United States Department of the Interior

Re: Minor Modification, Resource Recovery and Protection Plan (R2P2), Longwall Panel # 4, West Ridge Mine

WEST RIDGE RESOURCES, INC.
 West Ridge Mine
 Lower Sunnyside Seam
 LONGWALL PANEL #4
 REVISED SETUP FACE LOCATION
Scale 1"=600' 2000 Feet Date August 01, 2002

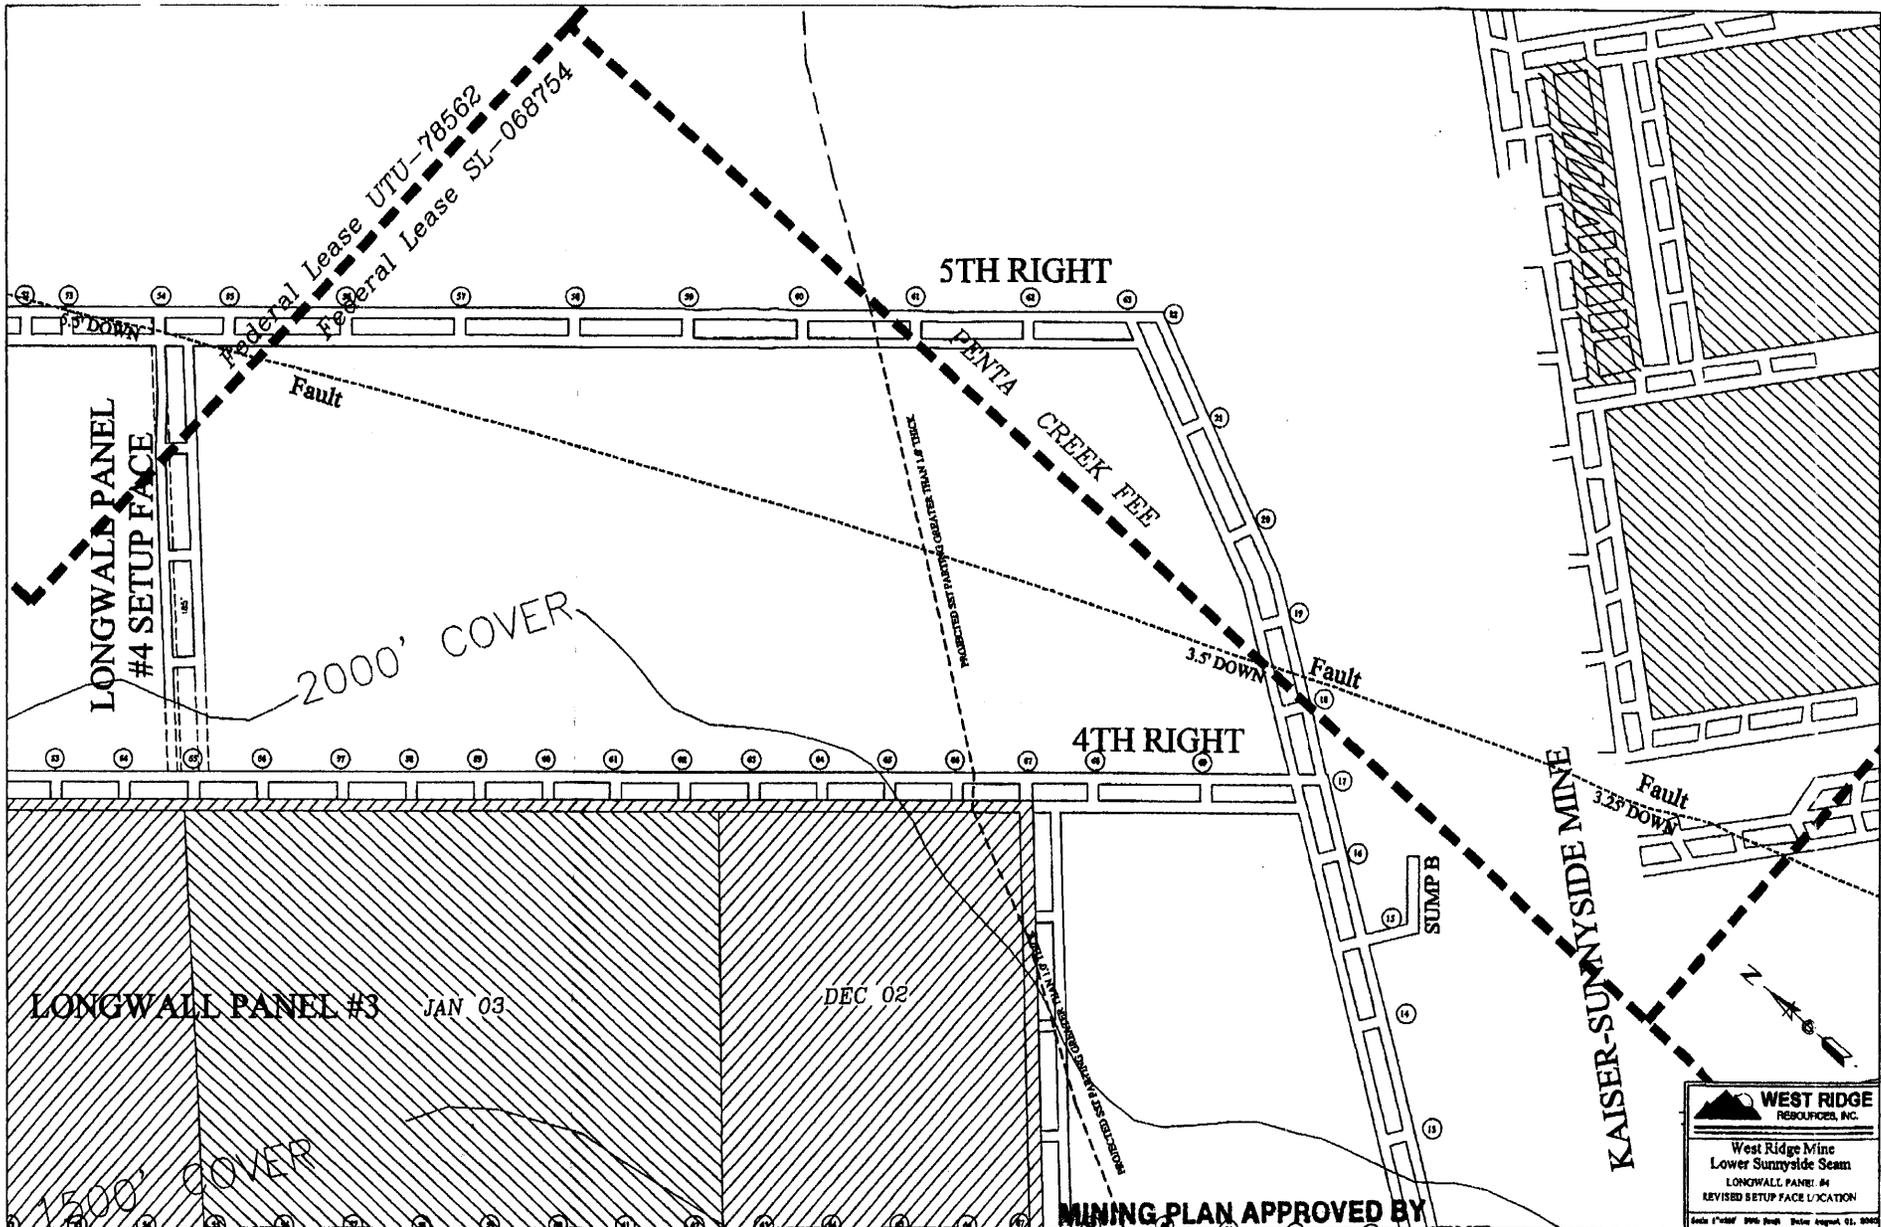
The BLM agrees that the longwall cannot be mined through this fault zone from crosscut 60 through 54 in 5th Right. The reasons are numerous and compelling. With the fault trending near parallel with the panel gates, the shear would have to grade through roof and floor rock on each shear pass. The floor and the roof rocks of the Sunnyside seam are extremely competent and hard sandstones and siltstones. Longwall shear passes grading through the fault zone make for high spark and ignition sources. This fact in conjunction with the high probability of methane and H₂S gas in the fault zone, makes for an unacceptable risk for fire and/or explosions. Coal quality will be marginal from the rock cut by the shear and productivity will be diminished to grade through the fault. The combination of these problems makes longwall mining through this fault area not physically or economically possible.

Recovery of this coal by continuous miners is also not possible. Access would have to be from a two-entry gate road with associated ventilation restrictions. Continuous miners would still have to cross the fault for much of the coal and run the same risks and the longwall shear. Also, any **unscheduled mining with the continuous miner would affect longwall development timing for future longwall panels.** We therefore agree that the coal between crosscut 54 and the back end of the panel is unrecoverable, about 280,000 tons of coal is no longer recoverable.

West Ridge's proposed change to the R2P2 complies with the Mineral Leasing Act of 1920, as amended, the regulations at 43 CFR 3480, the lease terms and conditions, and will achieve maximum economic recovery of the Federal coal. West Ridge is authorized to begin longwall extraction at crosscut 54 at the 5th Right headgate entry. This confirms a previous verbal approval of the proposed change. A copy of the approved mine map also showing the geologic features is enclosed.
